**UNITED STATES
NUCLEAR REGULATORY COMMISSION
ADVISORY COMMITTEE ON REACTOR SAFEGUARDS
WASHINGTON, DC 20555 - 0001**

SUBJECT: CERTIFICATION OF THE MINUTES OF THE ACRS ABWR
SUBCOMMITTEE MEETING, OCTOBER 20, 2010, ROCKVILLE,
MARYLAND

SUBJECT: CERTIFICATION OF THE MINUTES OF THE MEETING OF THE
SUBCOMMITTEE ON ABWR REGARDING COL APPLICATION OF
SOUTH TEXAS PROJECT (STP) ON OCTOBER 20, 2010

ADVISORY COMMITTEE ON REACTOR SAFEGUARDS
MINUTES OF THE MEETING OF THE SUBCOMMITTEE ON
ADVANCED BOILING WATER REACTOR (ABWR) REGARDING STP COLA
ON OCTOBER 20, 2010, IN ROCKVILLE, MARYLAND

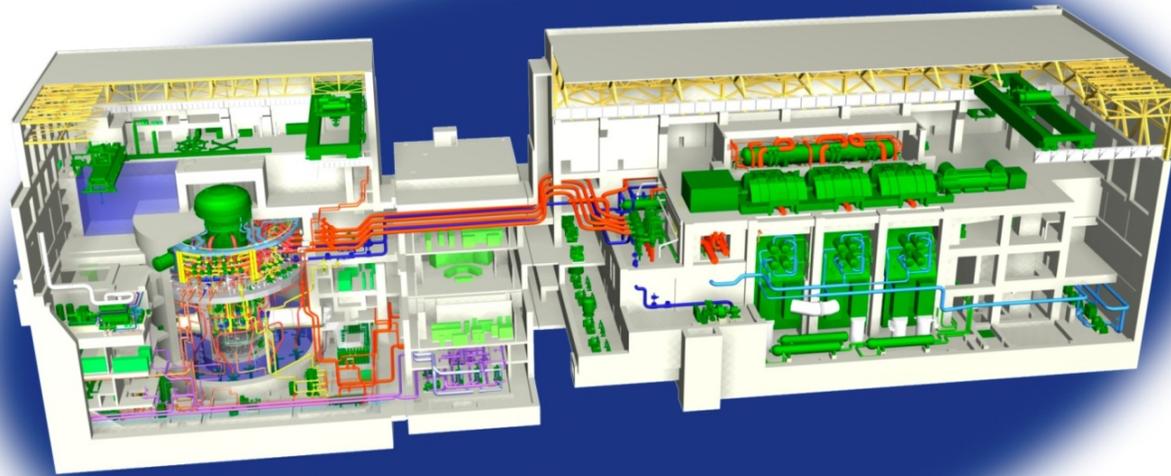
STPNOC discussed the results of the failure modes and effects analysis on flooder valve (Action Item 41). There was some discussion of the potential failure modes and method of detection

(lowering of suppression pool level). Member Bley asked if STPNOC considered a slow leak through the valve resulting in water in lower drywell. STPNOC will provide an update at a future meeting.

Apparent discrepancy between STD DEP 7.2-2 text and Figure 7.2-8

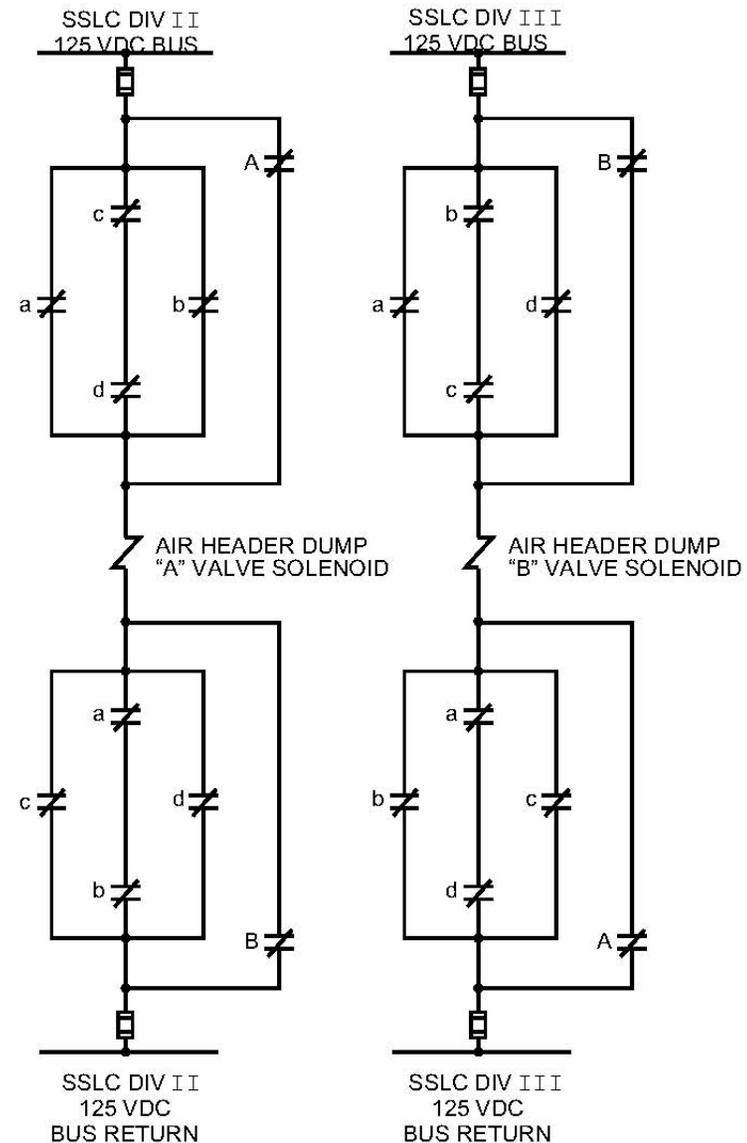
36	5/20/10	Dr. Stetkar pointed out a possible inconsistency between the diagram of the backup SCRAM control circuit and the description of that circuit in the text.	Chapter 14	FSAR/SER	STP/NRO	STP and NRO staff to address at a future meeting. Text clarification withdrawn by STP. Re: Slide 16, 17 of 10/20/10 ABWR SC briefing on Action Items.	10/20/10 closed

Response: The text clarification made by STD DEP 7.2-2, “Description of SCRAM Actuating Relays,” as presented in COLA in Revision 3, was withdrawn (U7-C-STP-NRC-100159, dated July 8, 2010).

This departure did not change the ABWR DCD design.

As described in Tier 2 Subsection 7.2.1.1.4.1 (3), when in a tripped state, the backup scram relay coils de-energize and close the normally-closed relay contacts to cause energization (125 VDC power source) of the backup scram air header dump valve solenoids to initiate venting the air header, causing the control rods to be inserted.

This description is consistent with the interrupting device arrangement in the scram logic circuitry shown in Figure 7.2-8, Scram Solenoids and Air Header Dump Valves Power Distribution.
